**Tasmanian Planning Scheme – Brighton
Draft Amendment RZ 2023-004
Burrows Avenue Specific Area Plan**

ATTACHMENT A - RESPONSE TO DIRECTIONS

Figure 2: Estimated no. of bedrooms for future dwellings (Source: Council records)

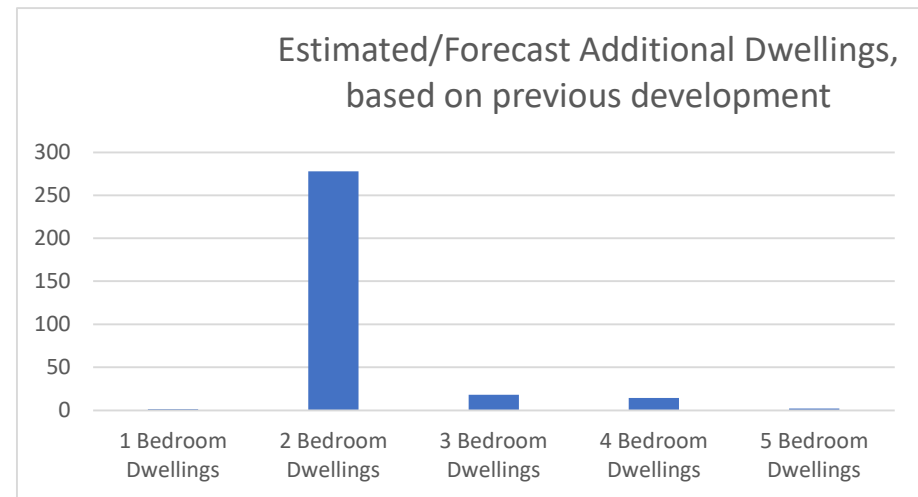
Given recent development history, both in the SAP area and throughout the Brighton Municipality, it is likely that the majority of those 27 lots will be developed with 2-bedroom units. This will have the effect of providing a significant oversupply of 2-bedroom units in the SAP area (Refer figure 2).

Figure 3: Estimated no. of bedrooms in existing and forecast dwellings (combined) at full development (Source: Council records)

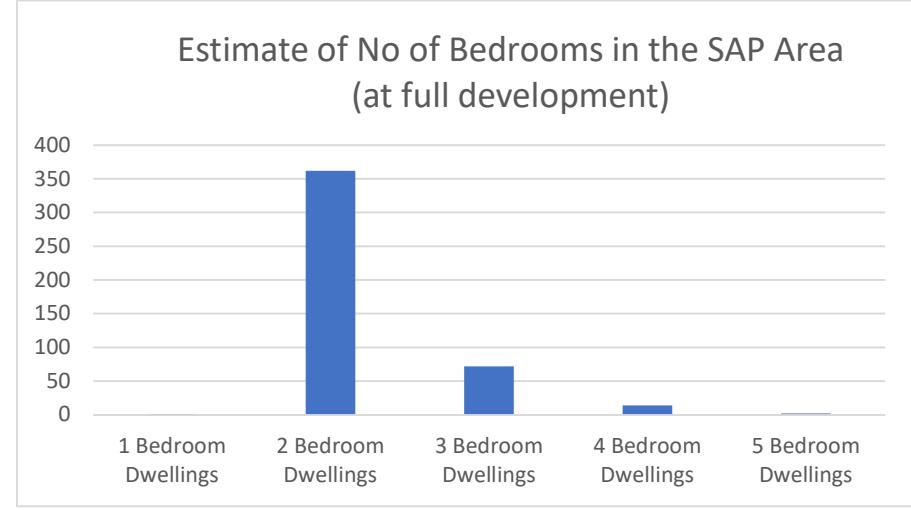
Figure 3 shows that combining the existing development and forecast development on its current trajectory will result in an oversupply of 2 bedroom dwellings and a lack of housing diversity

It is therefore submitted that the Plan Purpose should remain unchanged, other than removing 'greater'.
